SUBJECT SR-2000 Hold on Shipments

Subject: SR 2000 FIELD EVALUATION

SR-2000 PA WAFER SWITCH MODIFICATION

to: Mr. A. Dambrauskas
subject: P 2000 Power Supplies
copies: Messrs: R.J. Orwin, J. Maycan, R. Drobish

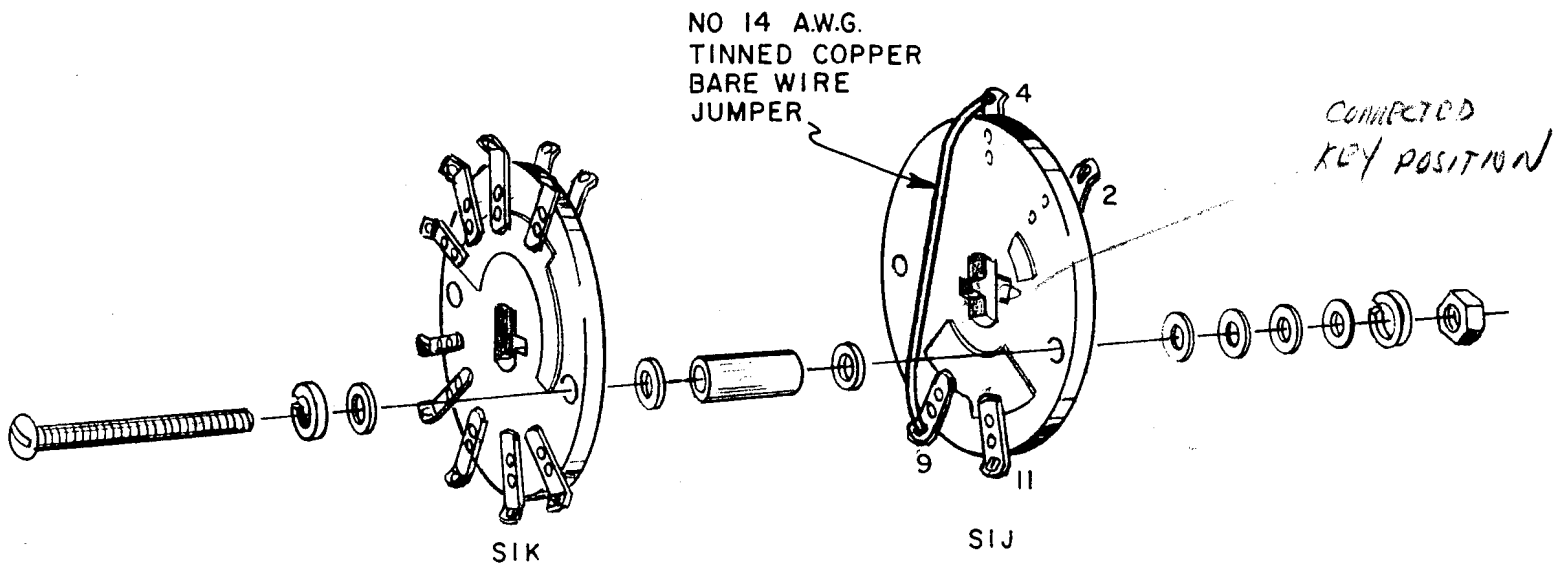
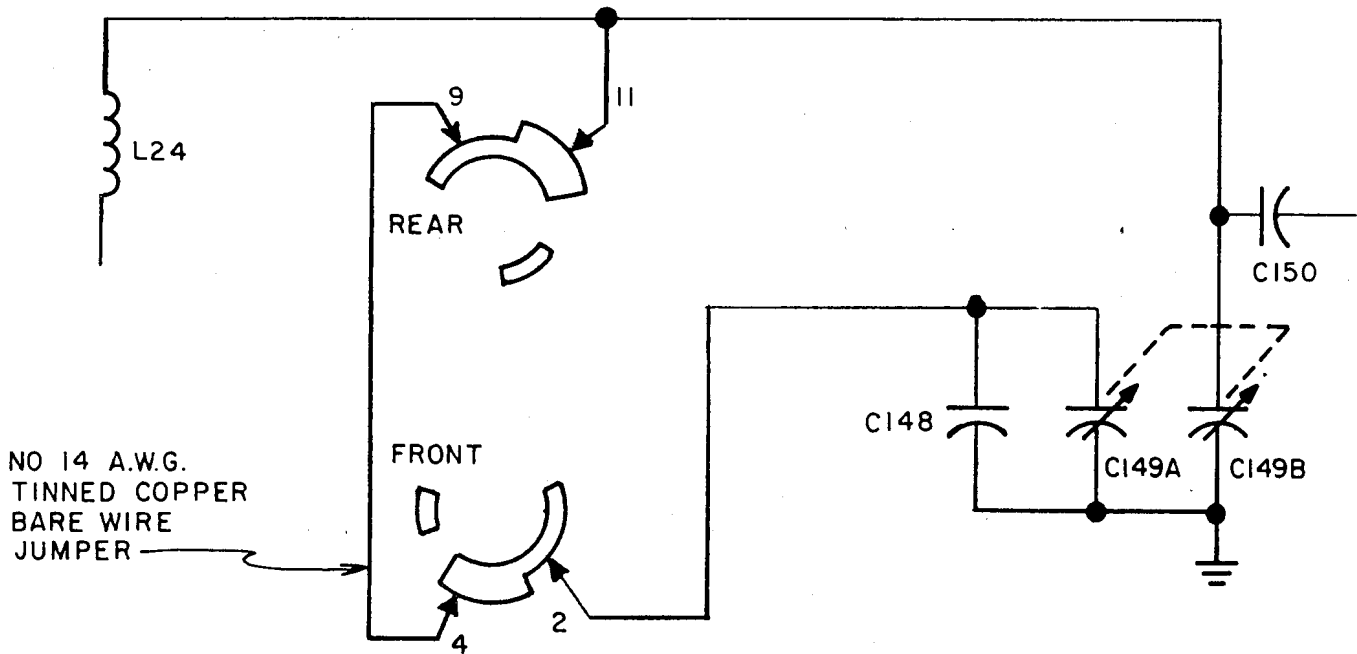
KEY ON ROTOR OF SIJ IS ORIENTED 180° FROM THAT OF SIK
